ADDENDUM NO. 1

June 14, 2024

**IPS Broad Ripple MS 717; Middle School Renovations
1115 Broad Ripple Ave.
Indianapolis, IN 46220**

Sheet CD-102 Demo Plan Rev. 1, 06/13/24, Addendum 01
Creative Engineering Solutions – Addendum No. 1, dated 06/13/2024, (39 pages)

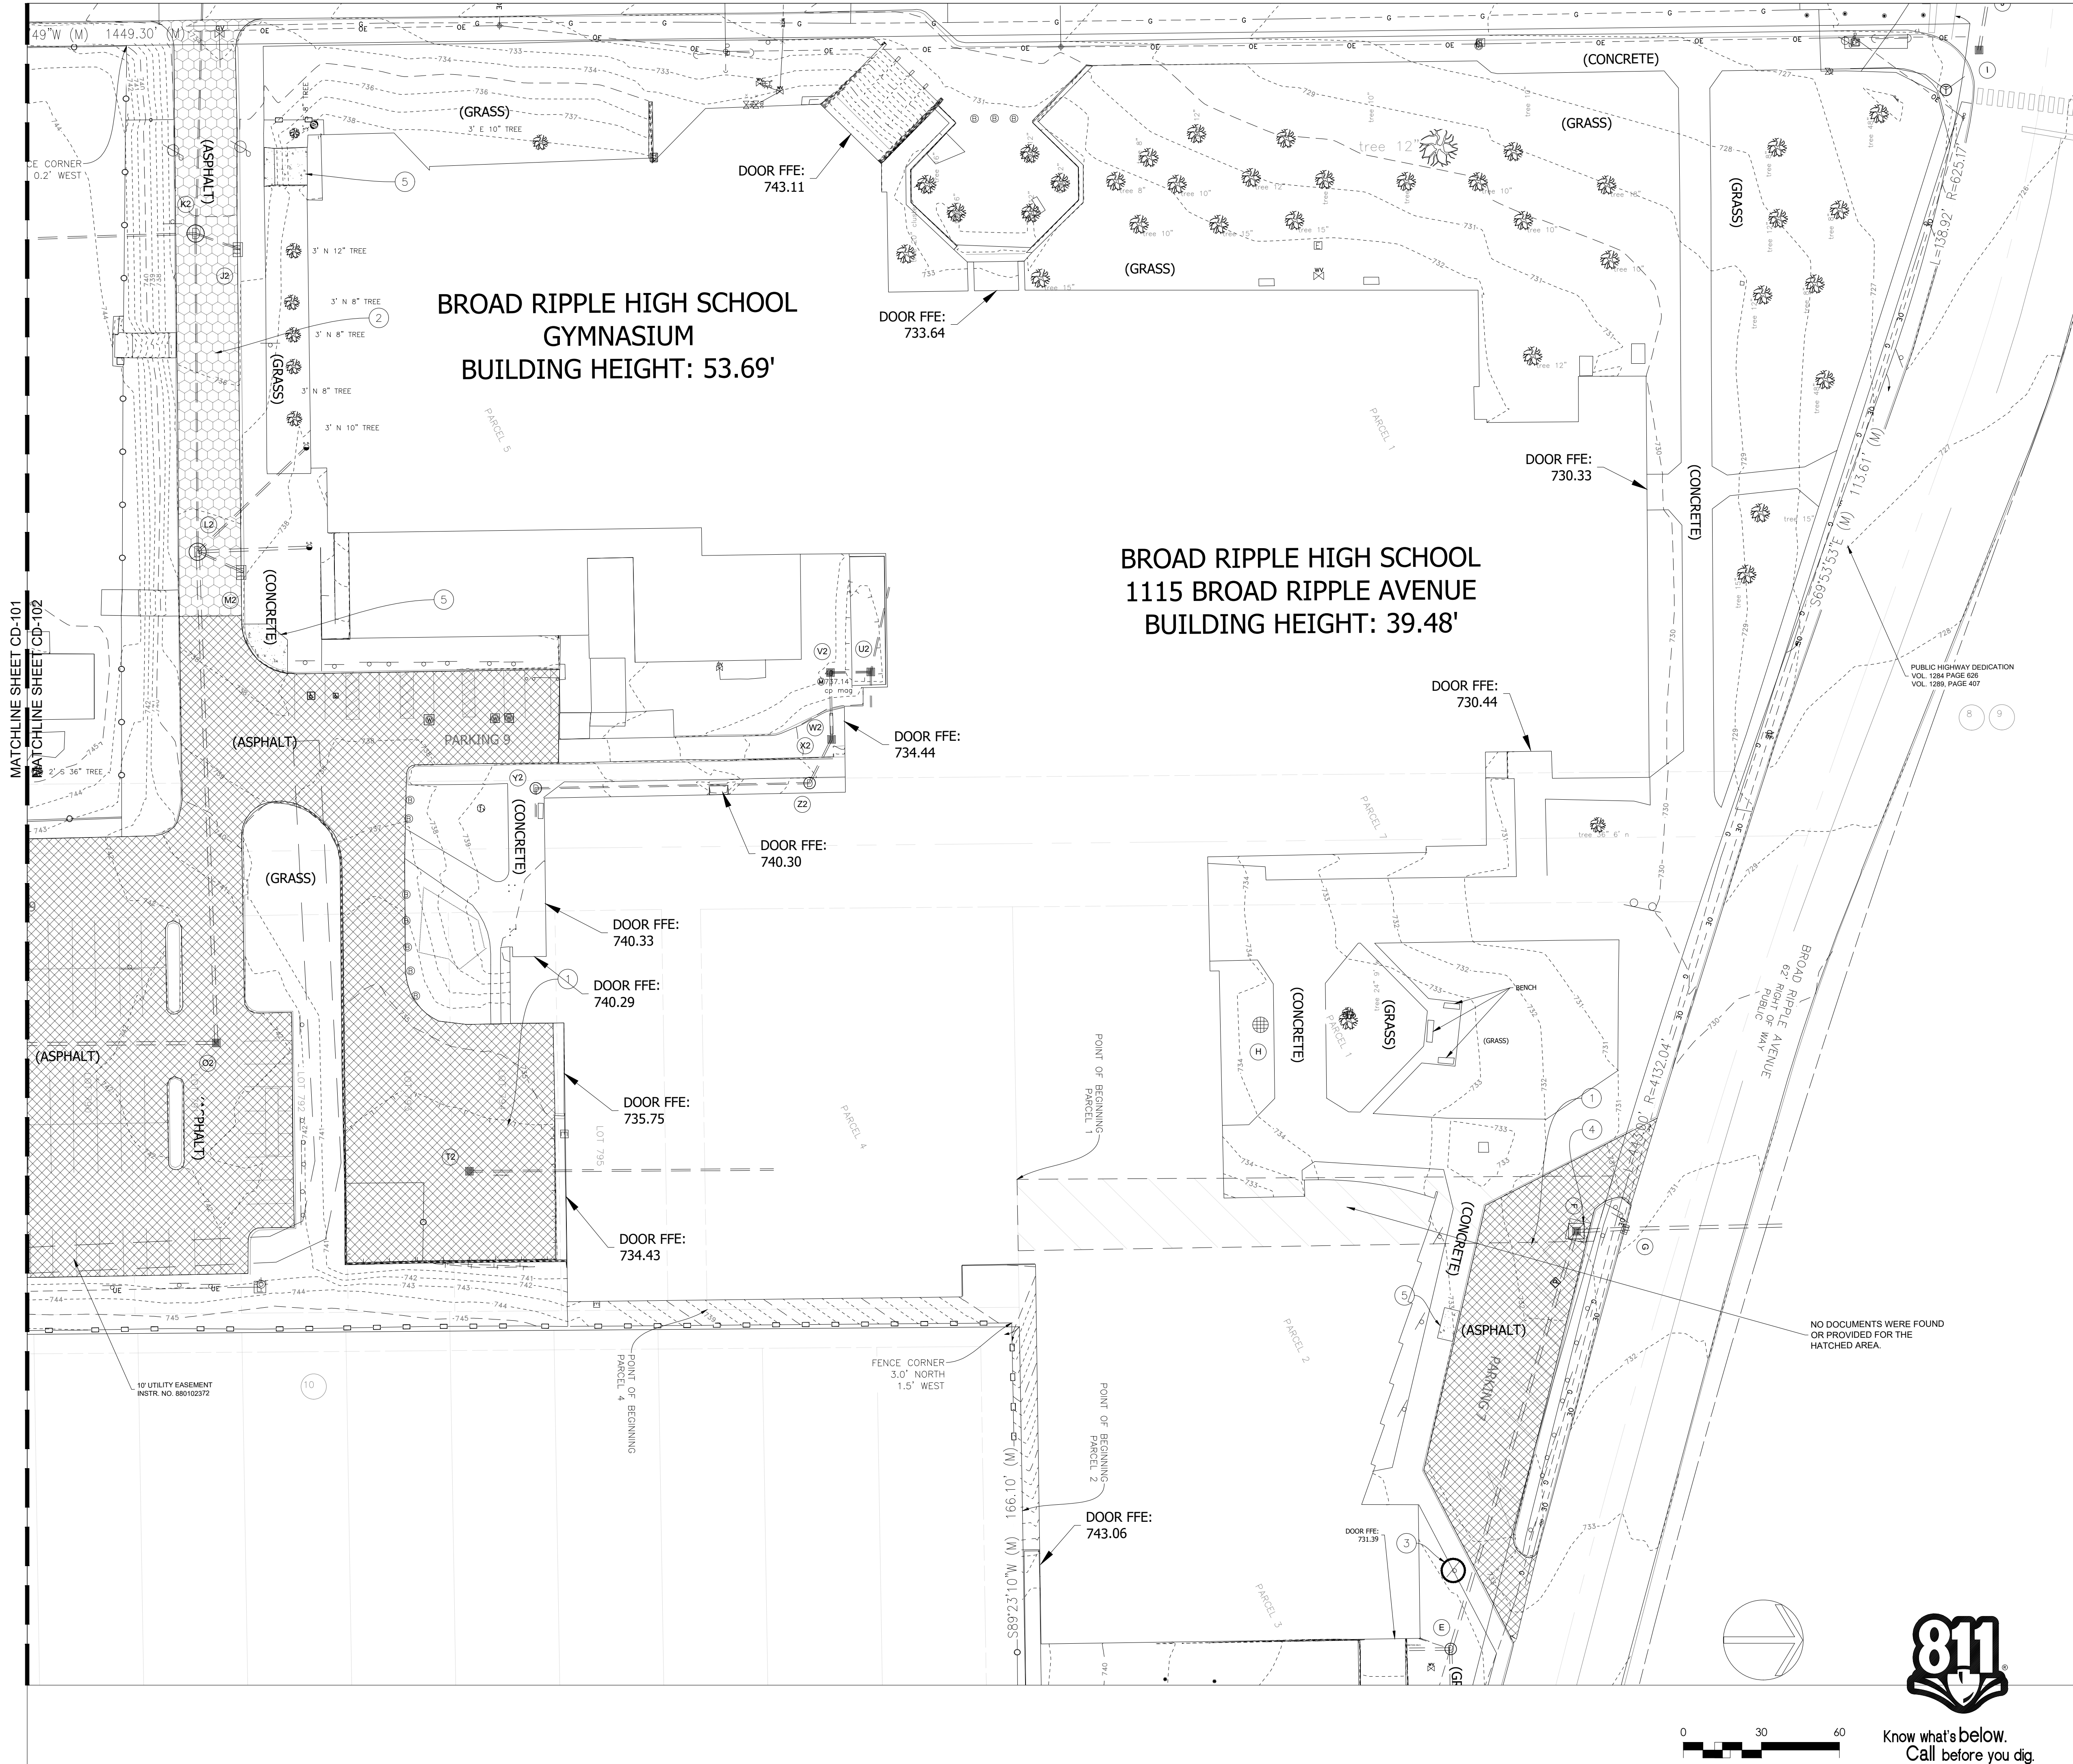
5. **Question:** Regarding drawing sheet CD-102 and CS-102; The area along Broad Ripple Ave. (north side of the building) changes shape and area on these two sheets. Please advise.

Response: The drawing viewport on sheet CD-102 has accidentally been shifted such that the entirety of the Work scope along Broad Ripple Ave. is not visible. The shape and area of this Work scope is as shown on sheet CS-102. Reference the revised sheet CD-102, attached.
